Internal Technical Document

Document # ITD-00045, Rev. E
Issue Date November 27, 2012
Printers Affected T1000

T1000 45100954 Ink Manager PCB Connection Diagram

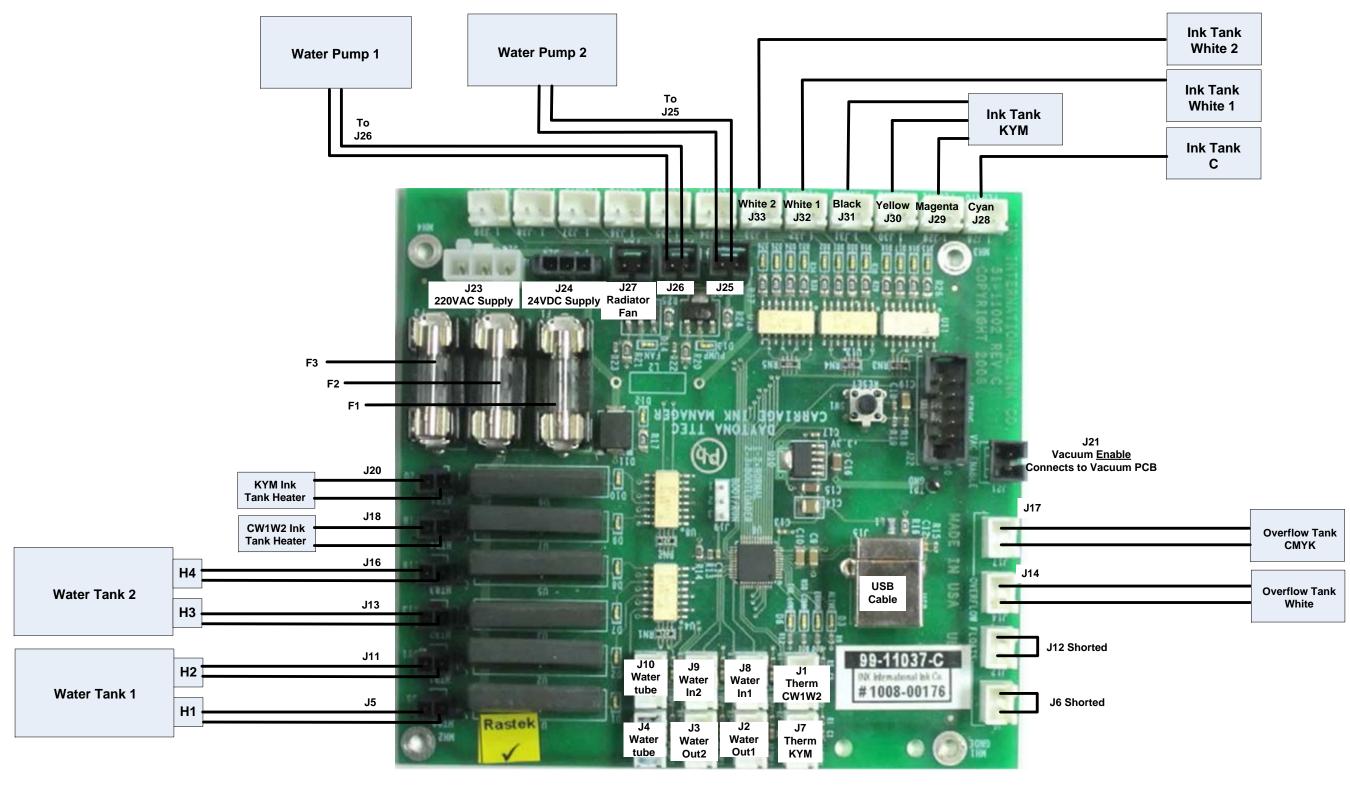
NOTE: Jumpers are required on J6 and J12 on all software versions. J4 and J10 thermistors have been removed on printer serial number T25 and above therefore a jumper will be required at J4 and J10. When installing version 3492 or greater software J4 and J10 thermistors can be removed and jumper installed at both connections.
